The Town of Hilton Head Island Regular Design Review Board Meeting

**Palmetto Electric Operations Area
Design Review Board Submittal**

DESIGN TEAM/ DRB COMMENT SHEET

PROJECT Palmetto Electric Operations Building

AO-1

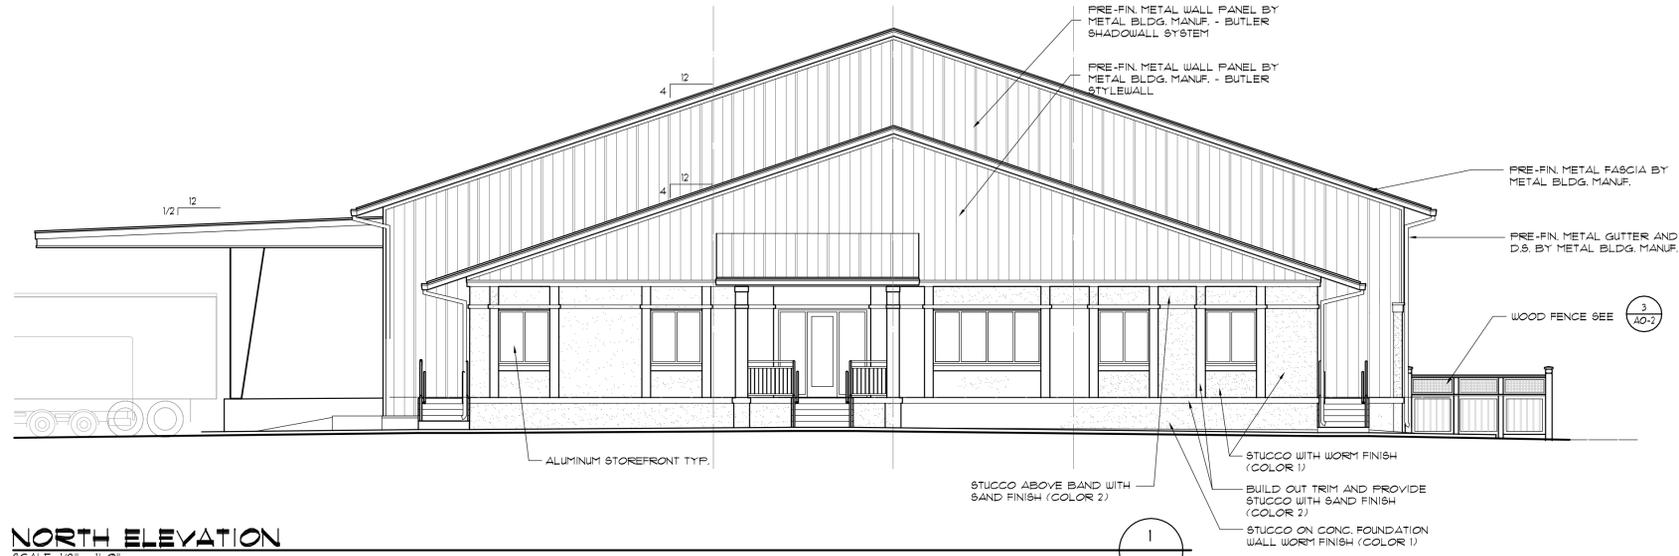
A metal operations building detailed to match newly redeveloped office facility. Materials, details, and colors selected to match and complement. Hard samples to be provided at the meeting. Architectural fence detail at public interfaces to marry into existing fence at rear. All existing storage and lay-down areas to be removed and parking to be reconfigured.

DESIGN GUIDE/LMO CRITERIA	COMPLIES YES/NO/NA	COMMENTS OR CONDITIONS
An effort has been made to preserve existing trees and under story plants		No accommodation has been made for the root system of the specimen 35 inch oak near the new main entrance; the new surface is all impervious and affects about one-third of the root surface area. Applicant should be encouraged to save additional trees, especially in the detention area. Detention should be planted with native plants to help biodegrade pollutants from impervious surfaces.
Supplemental and replacement trees meet LMO requirements for size, species and number		The planting plan shows sweet bay magnolia being installed. We have had very poor success on the island with this species over the years; it is recommended that 'Little Gem' magnolia be used instead.
Wetlands if present are avoided and the required buffers are maintained		
Sand dunes if present are not disturbed

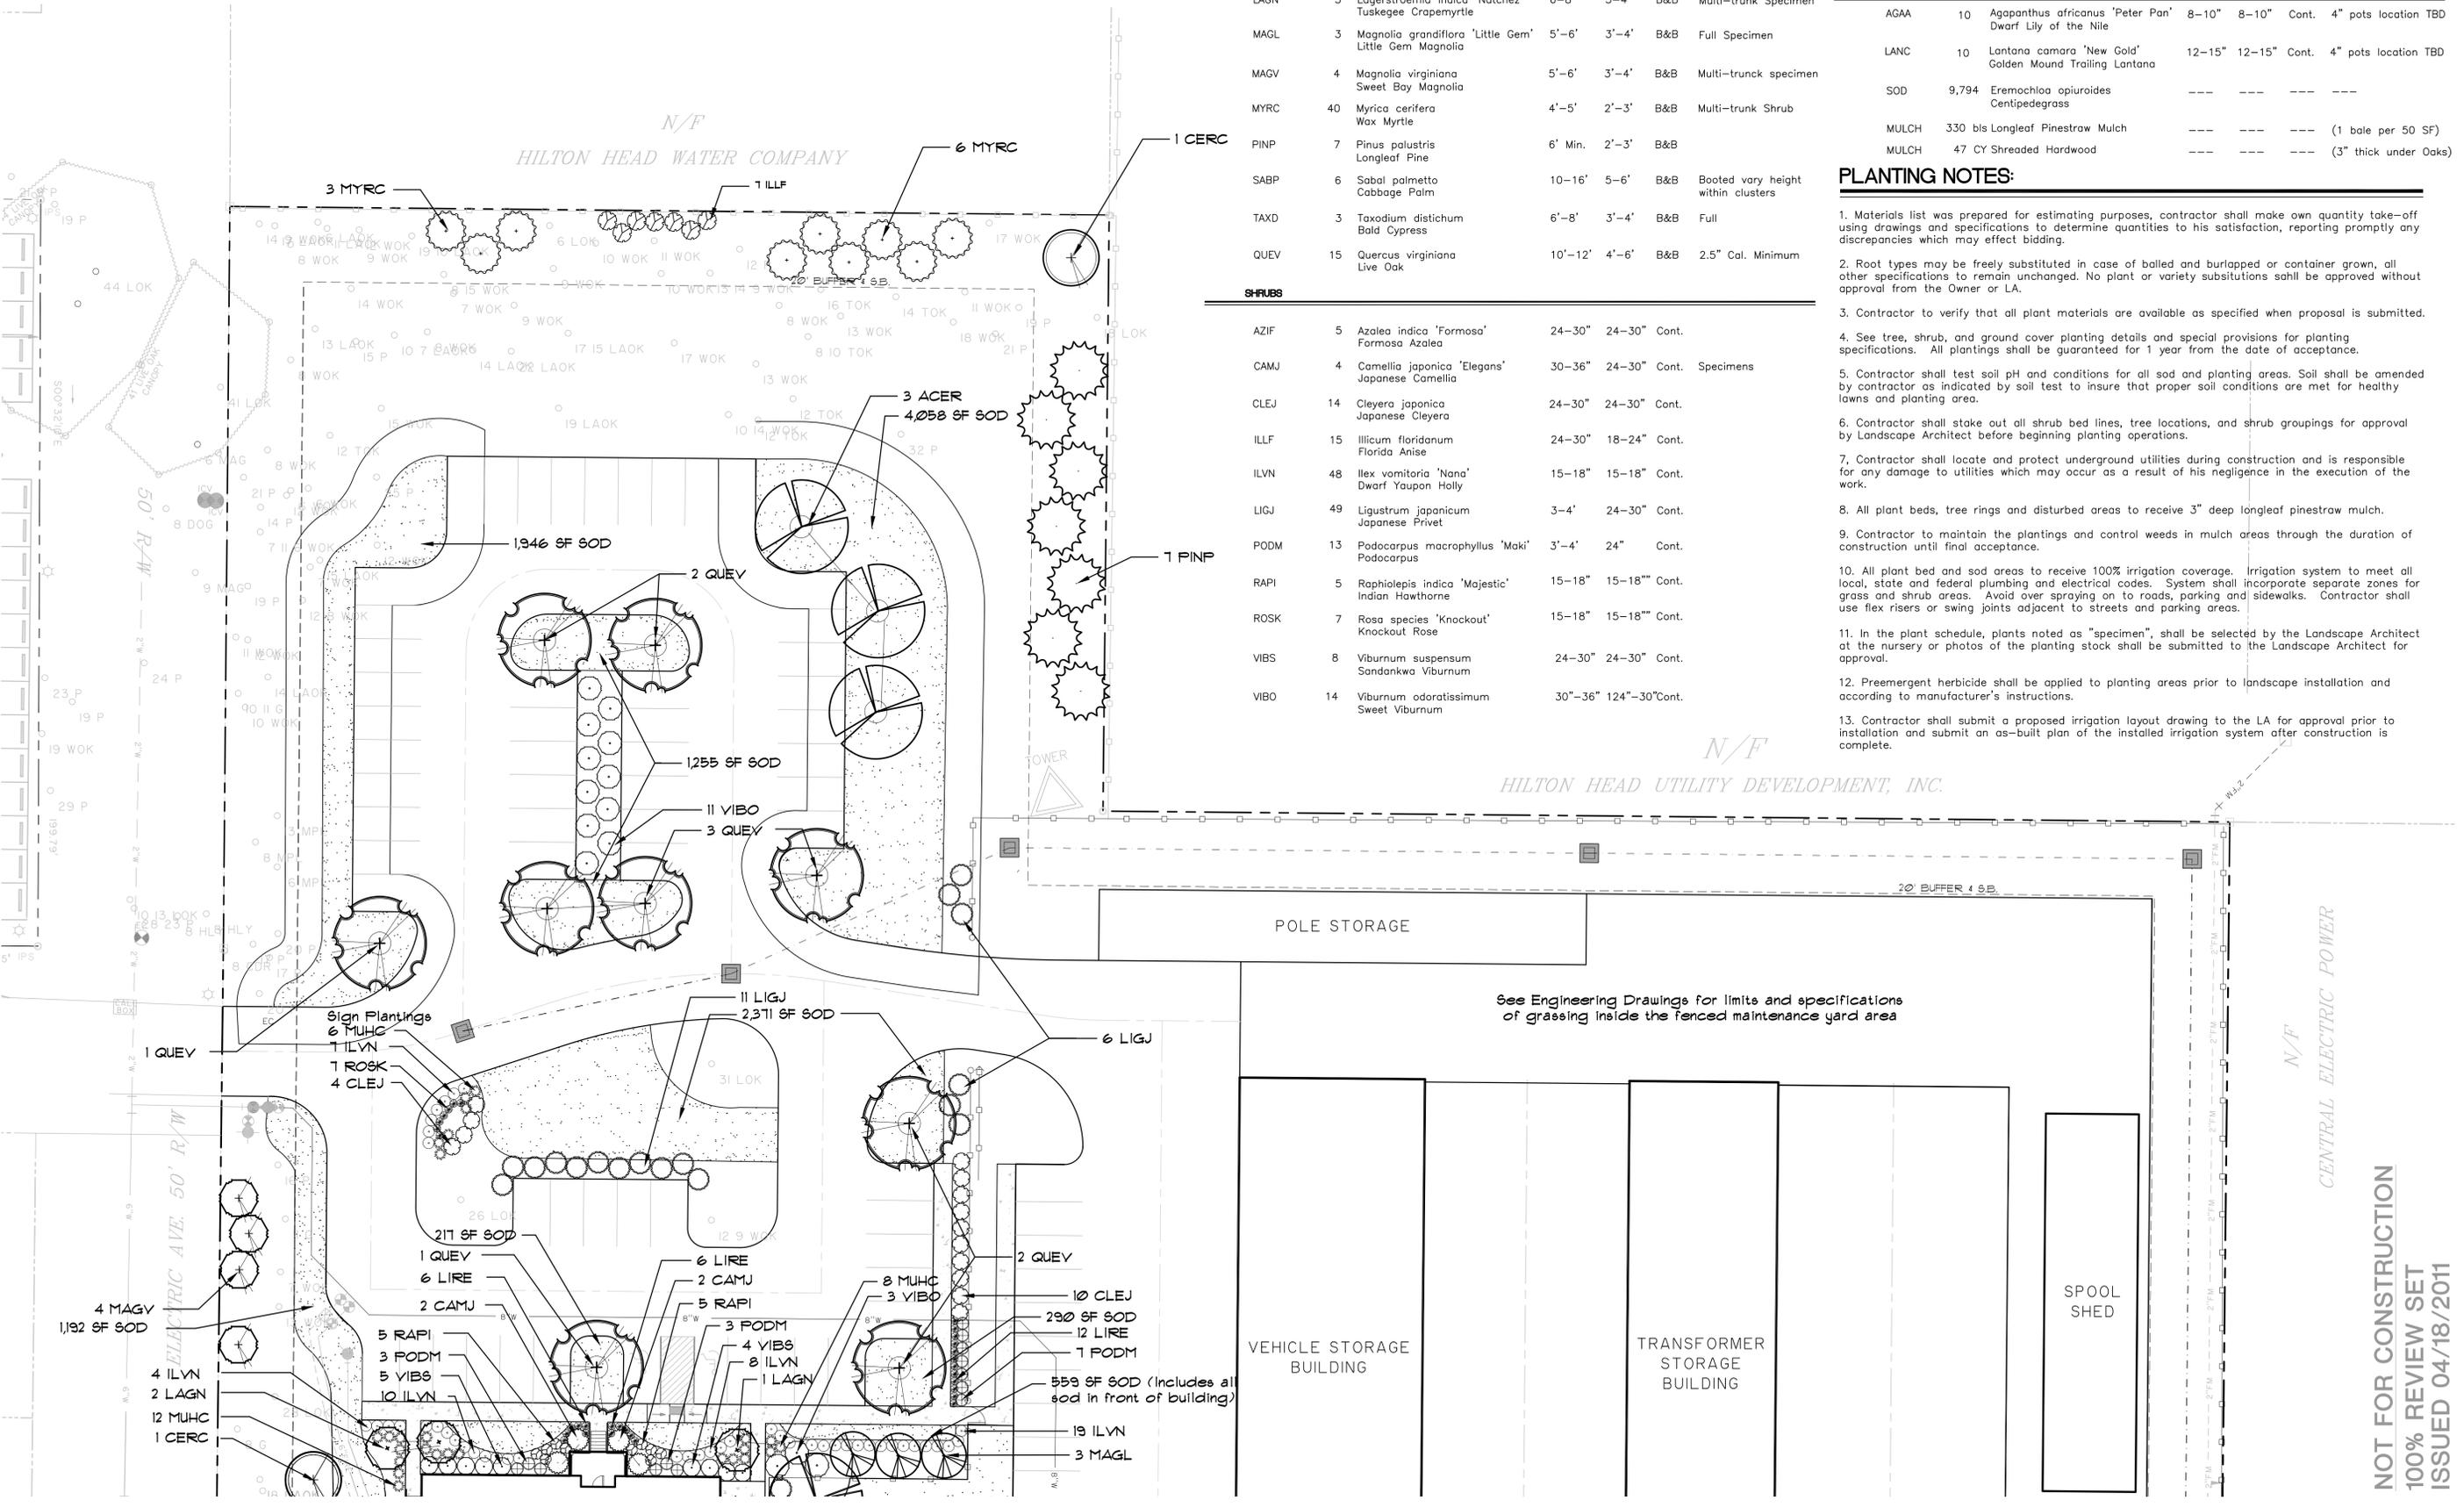
Might provide some understory along the outside of the fence along electric avenue (the Town is about to reconstruct the perpendicular streets with on street parking for a district parking provision), otherwise well above and beyond what one might expect for a predominantly utilitarian project.
